## CSC-10045088-8429

### Certain 2013 Model Year Lexus GS350 Vehicles Engine Control Module (ECM) Reflash

#### Customer Satisfaction Campaign

**TECHNICAL INSTRUCTIONS**  
**FOR**  
**CUSTOMER SATISFACTION CAMPAIGN CLA**  
**ENGINE CONTROL MODULE (ECM) REFLASH**  
**CERTAIN 2013 MODEL YEAR GS350**

### 2. REFLASH THE ECM

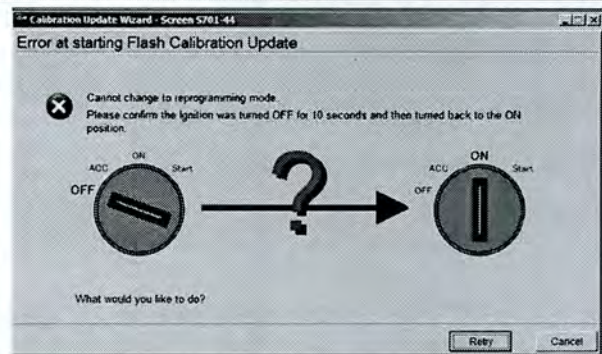
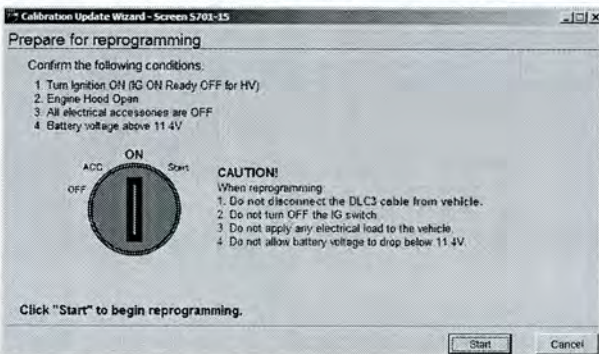
- a) Click yes on the health check results screen, or follow the links below to begin the reflash process.

MODEL	ECM	CURRENT CAL ID	UPDATED CAL ID
2WD	Main	330S2000	330S2100
	Sub	530G4000	Same (not updated)
4WD	Main	330S3000	330S3100
	Sub	530G5000	Same (not updated)

- If the Techstream does not have sufficient battery power the reflash will fail.
- Confirm the DLC3 cable is in good condition before attempting reflash.

After turning IG ON it may be necessary to wait an additional 25-30 seconds before pressing Start on the CUW.

If Start is pressed on the CUW before allowing enough time to elapse, an error may occur and the CUW will request that you retry the process.

### 3. ATTACH THE AUTHORIZED VEHICLE MODIFICATION LABEL

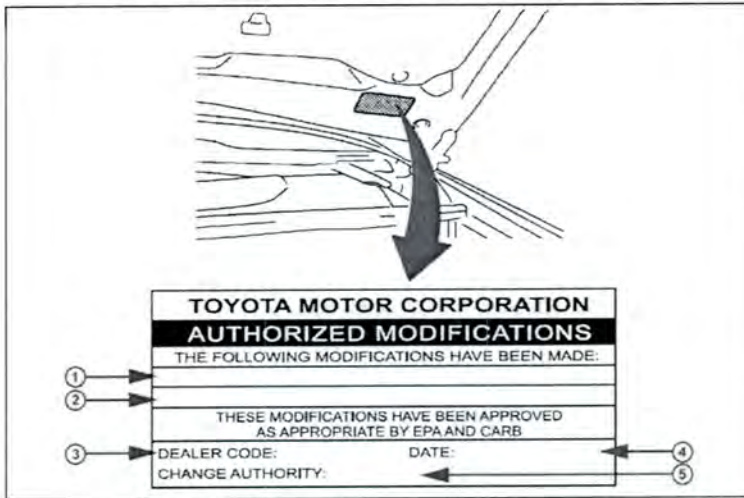
- a) Fill out the label.
- b) Affix the label to the under-side of the hood.

1	Replacement ECM P/N 2WD – 89661-30U51 4WD – 89661-30U61
2	New Calibration ID 2WD – 330S2100 4WD – 330S3100
3	Dealer Code
4	Date Completed
5	Campaign Code (CLA)
